Crime Prevention Through Environmental Design Review

ALKIMOS CENTRAL -CPTED REVIEW

CPTED Assessment

Prepared For Development WA
July 2021 (updated Nov 2021)

Figure 2 – Western PTA car park and passive surveillance.

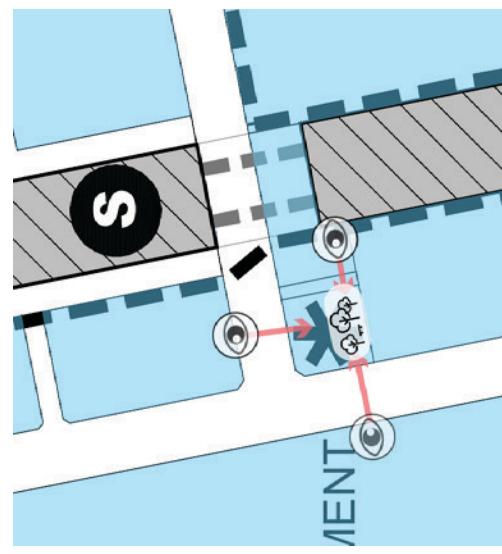
The PTA car parks to the north of the station are a vulnerable land use that will need further attention. Whilst these are not part of the project, they sit within the overall site boundary. To supplement the PTA's CPTED response for this car park, residential lots have been provided on the periphery to provide passive surveillance and overlooking of the western car park. Additional consideration of an at grade access point into the carpark from Brindabella and NS1 and a suitable approach to lighting is required at design stage of this car park.

- 1) Development adjacent to vulnerable land uses should be designed and oriented to provide passive surveillance and contribute to a sense of ownership of the space during the construction phase.
- 2) Lighting should be considered during detailed design phase.
- 3) Consideration should be made to facilitate additional security and surveillance during early stages of development.

Figure 5 – Interface with Dune Edge (prepared by UDLA).

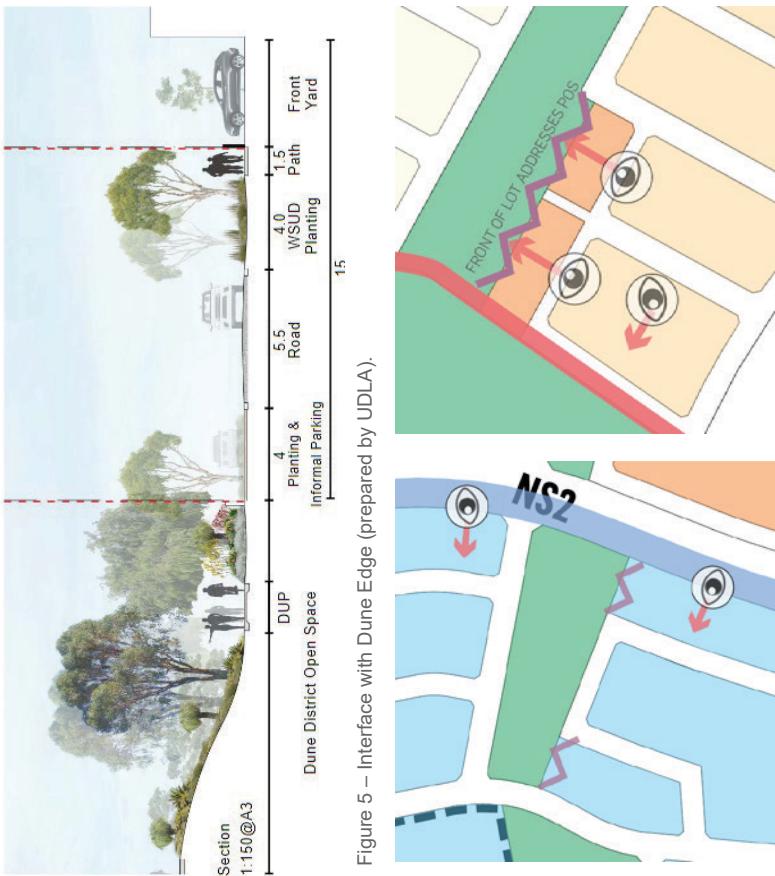
Streets fronting the dune edge have been provided with a minimum 15m width to ensure the inclusion of a footpath within the right of way and ample opportunity to facilitate safe and visible movements along the dune corridor. Indicative sections show clear sightlines to the footpath from the adjacent residential uses. Residential blocks adjacent to the dune are oriented parallel to the it, to minimise fence lines facing the dune. Where these do occur, we recommend that the housing at the block ends be oriented towards the dune to facilitate passive surveillance. Lighting associated with dune fronting streets should be provided on the dune edge to maximise visibility of these pathways.

The depth of the dune and associated topography means that some of the movement paths along the crest of the dune will be located out of site from the street edge. In these locations on both sides of the crest path lower lying shrubs are recommended to maintain good sightlines. This is in keeping with the typical dune vegetation types. Multiple access points to the crest path should be provided to minimise entrapment opportunities.

- 1) Provide a road edge against all public open spaces including the dune edge to increase passive surveillance.
- 2) Residential blocks are oriented parallel to the dune to minimise fence lines facing the dune.
- 3) Housing at the block ends be oriented towards the dune to facilitate passive surveillance
- 4) Clear sightlines to the dune footpath from adjacent residential uses should be maintained.
- 5) Lighting associated with dune fronting streets should be provided on the dune edge to maximise visibility of pathways.
- 6) Internal POS pathways provide lower lying shrubs to maintain good sightlines for path users.
- 7) Multiple access points along POS dune path should be provided to minimise entrapment opportunities.

Figure 7 – PTA underpass North and South – passive surveillance and alternate route.

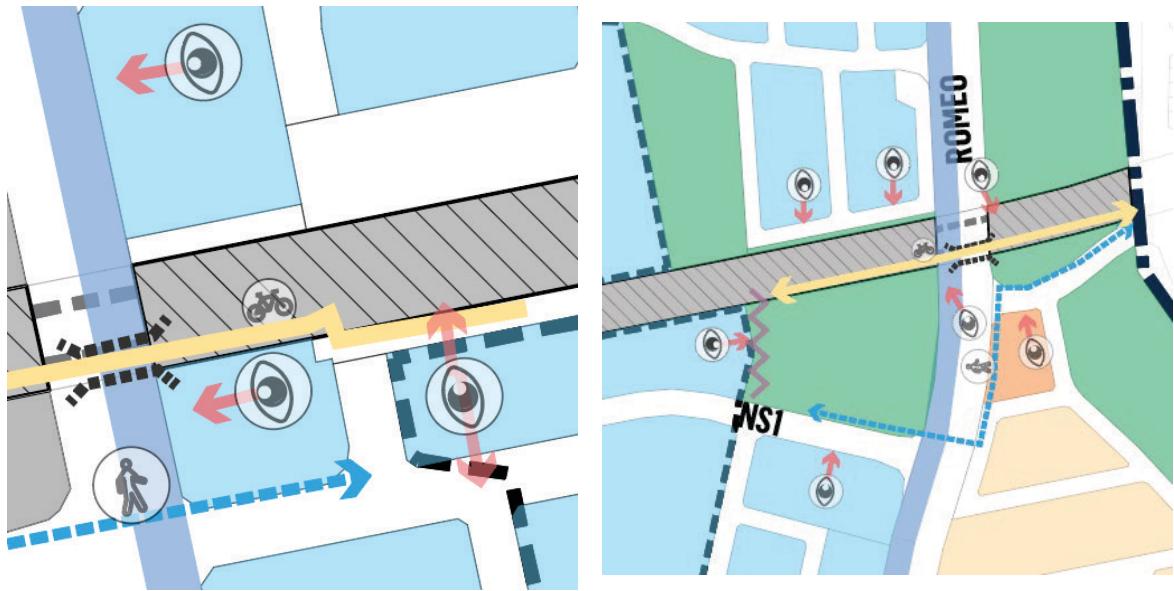
The underpass to the north connects the PTA car park to the PTA bus and train station under Brindabella. This underpass reconnects with the site adjacent to the Bus Station but behind a line of structures along Main Street (NS1). This potentially creates a location with limited passive surveillance. To address these concerns an alternate at-grade route between the station and the car park has been provided along Main Street that will provide an activated and well lit route between these uses. Within the PSP path and underpass itself we recommend maintaining low scale vegetation between the bus station and the PSP to ensure sightlines are maximised. We recommend that buildings along the eastern edge of NS1 provide views to the east overlooking the bus station and PSP. Lighting along the PSP edge particularly between the station and the car park will also be important to improve visibility.

The southern underpass connects via the rail reserve under Romeo Road. Public Open Space (POS) sits on either side of this underpass. The POS to the north is an activated open space and has cultural significance incorporating an indigenous site (the ‘pinnacles’) and also a threatened ecological community (TEC). The pinnacles feature sits below the street grade in a bowl. However, this POS will have a level of activation associated with the cultural feature and also sits on the edge of a high traffic intersection (NS1/ Romeo Road) with the entry to main street.

It is recommended that adjacent land uses to the north and west front this POS. This will assist in providing passive surveillance of the open space and adjacent underpass. The POS to the south of the underpass is more isolated and will have less opportunity for overlooking. It is recommended that this POS have clear sightlines to the PSP and underpass from Romeo Road and NS1 extension and provide connections to the at grade path along the street edge. An alternate pedestrian/cycle route also exists at grade street along NS1.

- 1) **Minimise the use of underpasses and overpasses across the site and provide alternate routes in tandem where these do occur.**
- 2) **Where underpasses and overpasses occur on site, or adjacent to the site, ensure clear end to end sight lines from surrounding land-uses and movement systems to improve passive surveillance.**
- 3) **Where overpasses are shown, ensure that a range of access points are provided to minimise entrapment opportunities.**

Figure 8 – Crest Walk with alternate connections and low scale planting

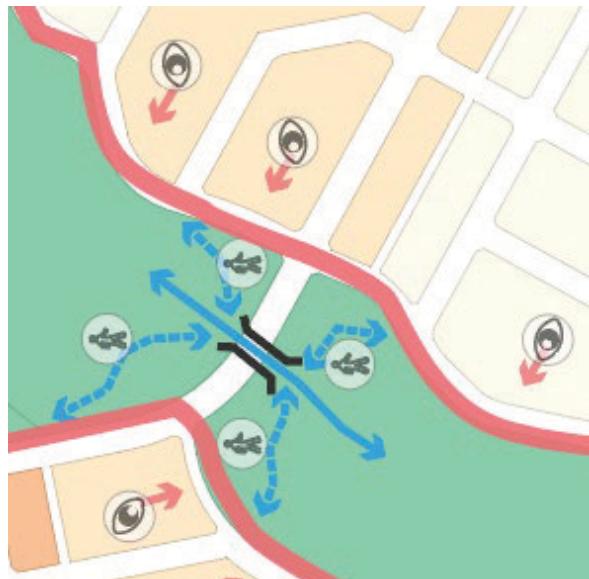
There are six (6) overpasses indicated within Alkimos Central along the crest walk route. These form part of a wider movement system offering an off-street movement opportunity. The length of each crossing is different and the context changes with four road and two rail crossings achieved. These crossings all cover what will likely be busy movement corridors including the rail, NS1, NS2, Romeo Road and Tuart Drive. Visibility from the street to the overpass should remain clear to passing movements. Each crossing point has a range of access links shown to limit entrapment points and ensure a range of movement choices. These routes connect back to residential areas as part of Alkimos Central or adjacent residential neighbourhoods. It is recommended that these routes be constructed as part of the development process.
